SERVICE BULLETIN

APPLICABILITY: 2013MY BRZ

NUMBER: 02-151-14R

SUBJECT: Revised Valve Train Parts to Reduce a Warm Engine Tapping Sound from the Left Cylinder Head

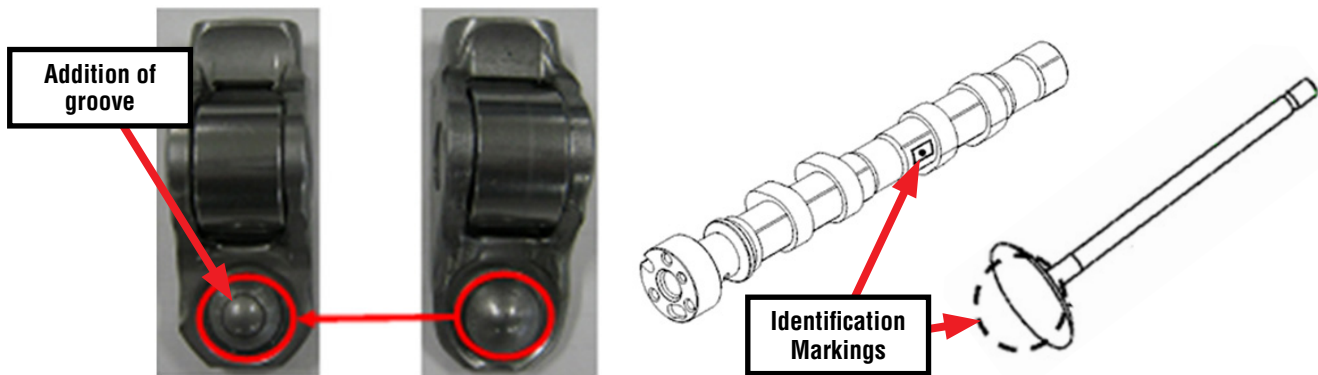
- Design change to the valve rockers
- Camshaft profile change
- 1.65mm longer intake and 2.47mm longer exhaust valve stem lengths

The illustrations below show additional information about the changes to the valve rockers, camshafts and valves to help readily distinguish them from the previous version parts.

If you receive a customer concern of a tapping sound from the B2 cylinder head, confirm it is isolated to the B2 valve train area before proceeding with any repairs. Once verified, order and replace the intake and exhaust camshafts, the 4 intake valves, 4 exhaust valves, all 8 rockers and all 8 pivots. Refer to the service procedures outlined in the applicable Service Manual for installation.

NOTE: When setting the valve clearances, the intakes should be set to 0.13mm +0.02 / - 0.03 and the exhausts set to 0.22mm +/- 0.02. **These are revised clearance specifications and are not reflected in the Service Manual.**

IMPORTANT: Do not mix old and new parts together as it will become impossible to obtain intake valve clearances that are within specification.
